6. COA-076905-2020

Commission of Architectural Review

STAFF REPORT

Replace concrete walkway with bluestone.

Figure 1. 316 North 36th Street, view from street

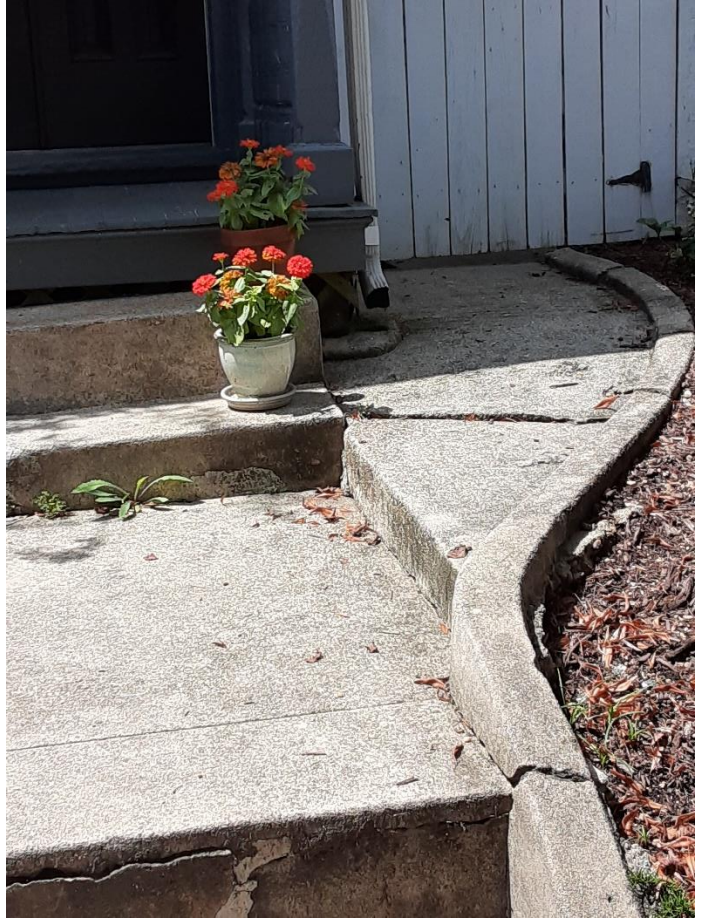
- The applicant requests approval to replace deteriorated paving material at the front of the home.
- The existing house is a 2-story frame Italianate house built ca. 1910.
- The concrete steps from the sidewalk to the porch steps are deteriorated and do not meet current building code. The applicant is proposing to replace the steps with new concrete. New metal handrails will also be installed at the replacement stairs.
- A concrete pathway to the side of the house will be removed and replaced with bluestone stepping stones.
- The applicant also proposes to replace a rear wooden privacy fence in-kind.
- Other work is also planned at the rear, which is not visible from the public right of way.

The applicant is proposing to replace the existing concrete steps and curbing with new concrete. As the Guidelines call for simple

- The new concrete curbing match the heights of the adjacent curbing, matching the existing curbing.
- The concrete walkway to the side yard that is visible from the street be replaced in-kind with new concrete to match the existing design.
- Final specifications for the fence be submitted to staff for administrative approval.
